North Eastern Indira Gandhi Regional Institute of Health and Medical Sciences  
(An Autonomous Institute, Ministry of Health and Family Welfare, Government of India)  
Director's Block, Mawdiangdiang, Shillong 793 018 (Meghalaya)

**e -TENDER AMENDMENT**

Reference Tender Enquiry No: NEIGR/S&P/OT/E -14/2018 -19 for processing of 3.0 Tesla MR Scanner, with 5 years warranty, thereafter 5 year CMC and with complete turnkey works, for department of Radiodiagnosis and 2<sup>nd</sup> pre bid /clarification session held on 15.05.2019 .

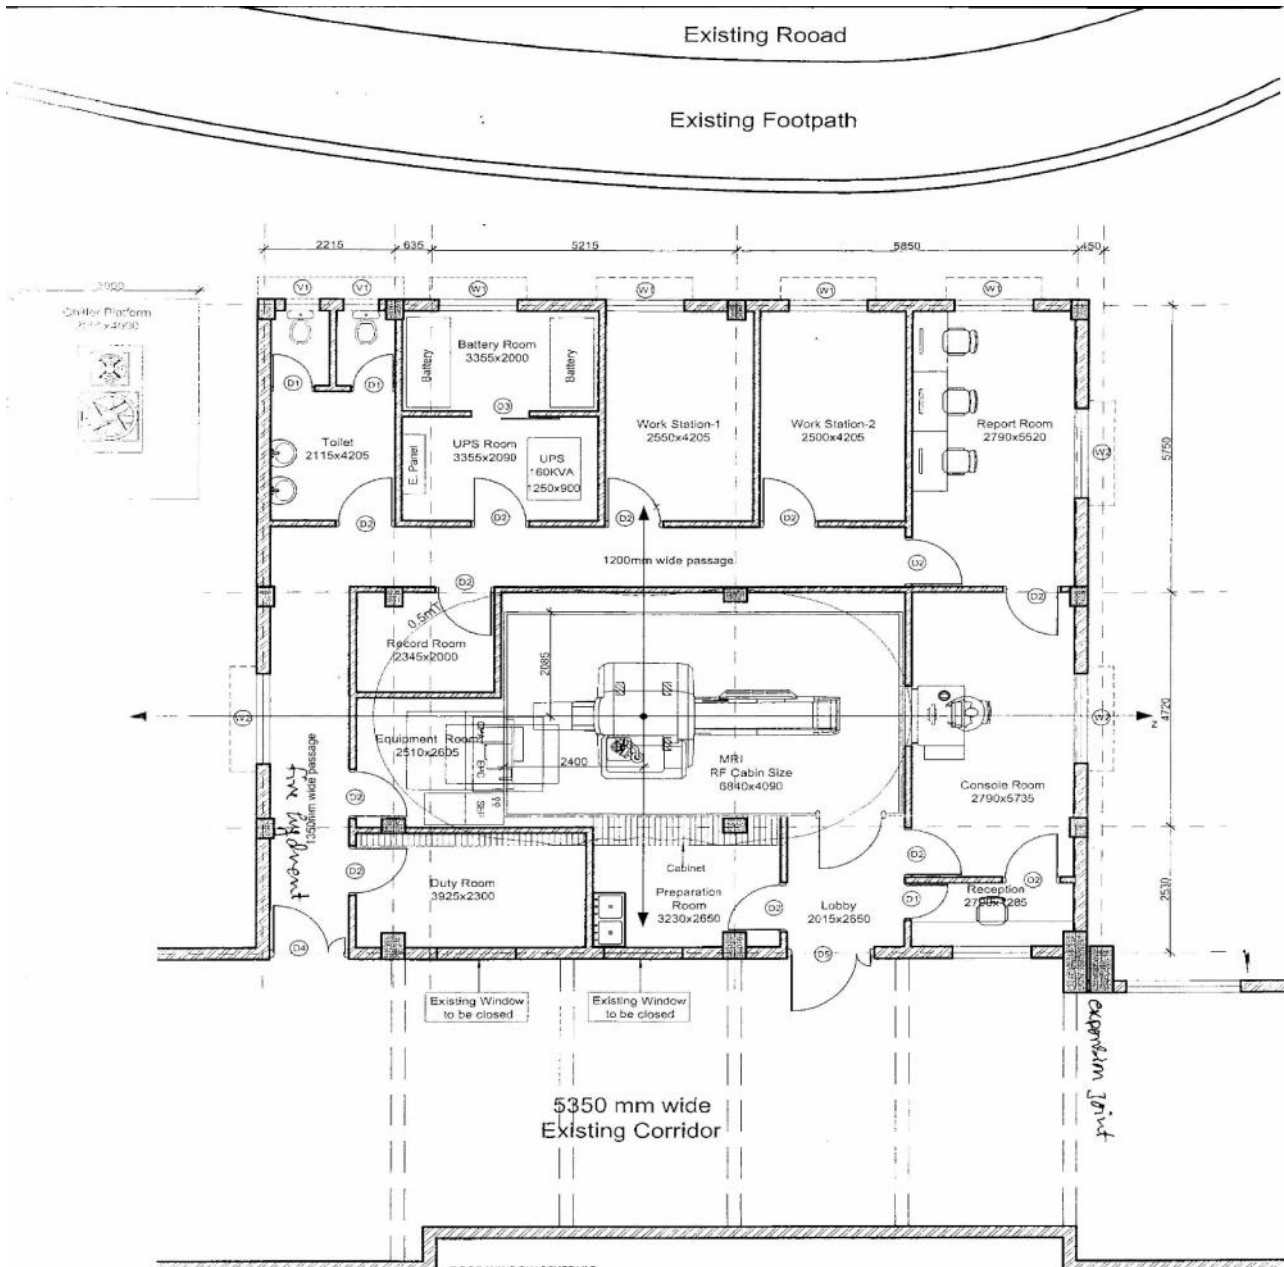
17. The Civil/Electrical /Turnkey work has to be completed as per the attached drawing & must complied with the technical Specifications.The supplying & laying of electrical cabling (from the Hospital main panel room to the MRI LT panel must be included in the turnkey works .The rooms must be connected through LAN & telephone cables internally .Light Dimmer Control must be provided in the console reporting & the work station rooms.
